Change Order | Allowance | Pay App Transmittal

PROJECT:	Ogdensburg City School District 2023 Capital Outlay Project 2023-008	DATE SENT:	12/28/2023
		RETURN BY:	1/8/2024
SUBJECT:	FO 201-01 Pumps P-1 & P-2	CHANGE ORDER ALLOWANCE PAY APP ID:	02 (MC) PA-005
TYPE:	Change Order Allowance Pay App	TRANSMITTAL ID:	00333
PURPOSE:	CO/AA For Signature to Owner	VIA:	Email
ACTUAL AMOUNT:	(\$1,847.85)	ESTIMATED AMOUNT:	(\$1,847.85)
ACTUAL DAYS:	0	ESTIMATED DAYS:	0

Project:	2023 Capital Outlay Project	Field Order No.:	201-01
Owner:	Ogdensburg City School District 1100 State Street Ogdensburg, New York 13669	Date:	December 13, 2023
Contractor:	Burns Bros. Contractors, LLC 400 Leavenworth Ave. Syracuse, NY 13204	Architect's Project No.:	2023-008
SED No.:	51-23-00-01-0-007-025 Ogdensburg Free Academy / Golden Dome	Contract For:	No. 2 - Mechanical
		Contract Date:	July 3, 2023
		SED Project Manager:	Wendy Clark

Subject: MC-01 ICE MELT SYSTEM MOTOR STARTERS

HEATING SLAB PLAN
M101
SIB SET

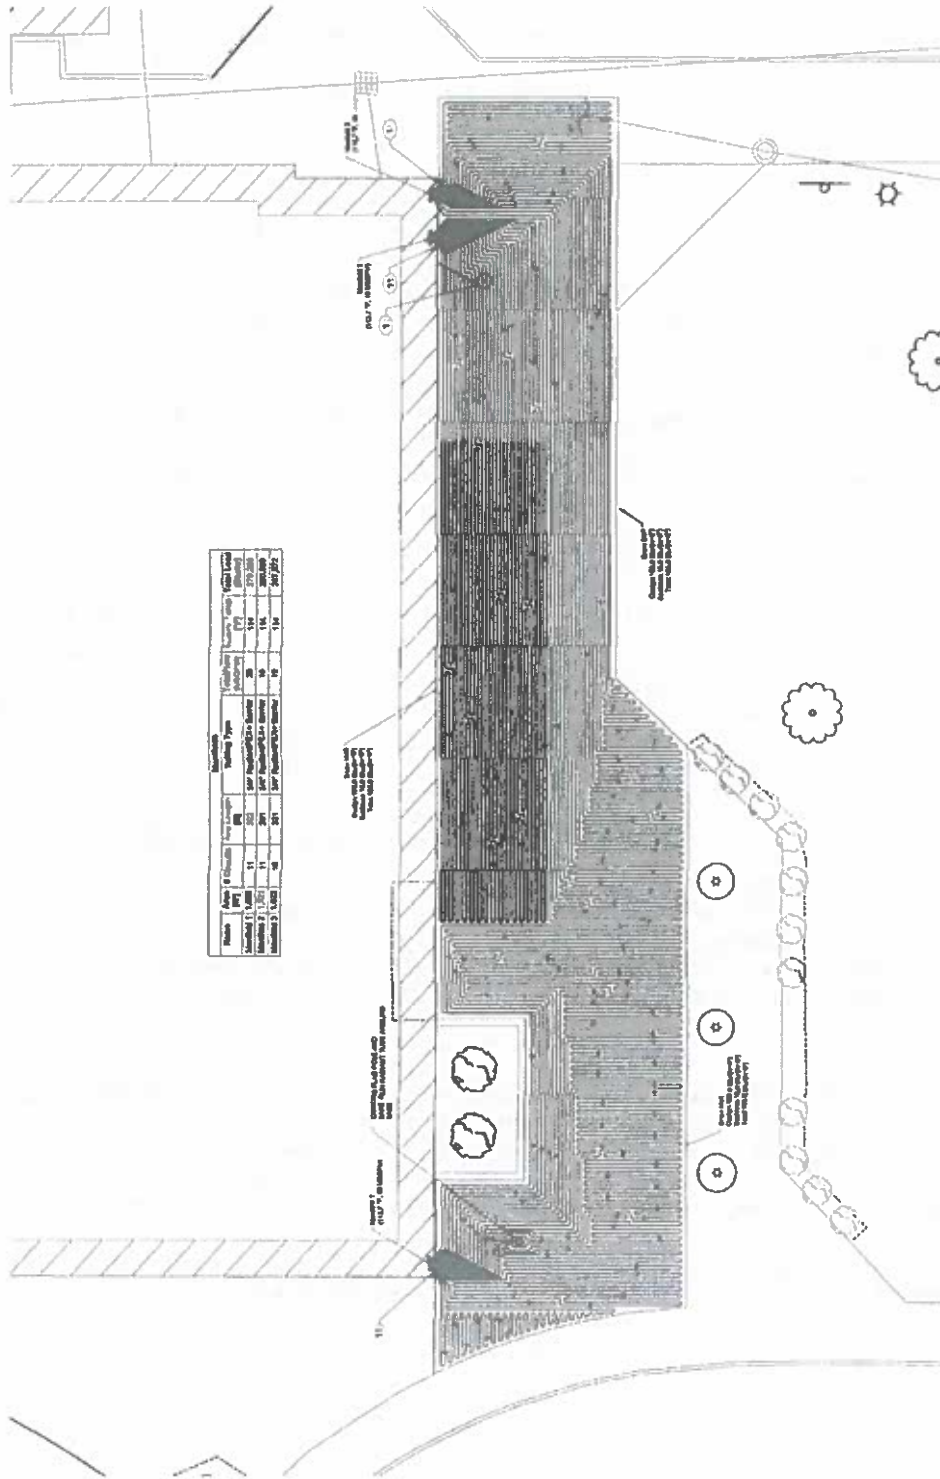
Add for all labor, materials, and equipment to provide magnetic motor starters and related temperature control interface on pumps P-1 & P-2 located in Mechanical Room F147 that serve the new snow/ice melt sidewalk system.	\$	1,847.85
Total Allowance Authorization Amount		\$ 1,847.85

A.	Mechanical Contractor
B.	Under the Capital Outlay Project, existing sidewalks were scheduled to be replaced with a new hydronic radiant heating system for the purposes of melting winter ice & snow as per Contract Drawing M100 and M101.
C.	During construction, the Mechanical Contractor discovered that the circulation pumps were without magnetic starters for under-voltage & overload protection as well as for an automatic cutoff in the event of a power failure. As such, the Mechanical Contractor provided HOA (Hand-Off-Auto) starters & controls on new pumps P-1 and P-2 to create a soft start on the new ice/snow melt system.
D.	Add for all labor, materials, and equipment to provide magnetic motor starters and related temperature control interface on pumps P-1 & P-2 located in Mechanical Room F147 that serve the new snow/ice melt sidewalk system.

- Provide material and labor for two (2) new magnetic motor starters for two (2) new pumps P-1 and P-2 with H-O-A switch and 24-volt controls for interface with temperature controls contractor/system. Coordinate with EC as required.
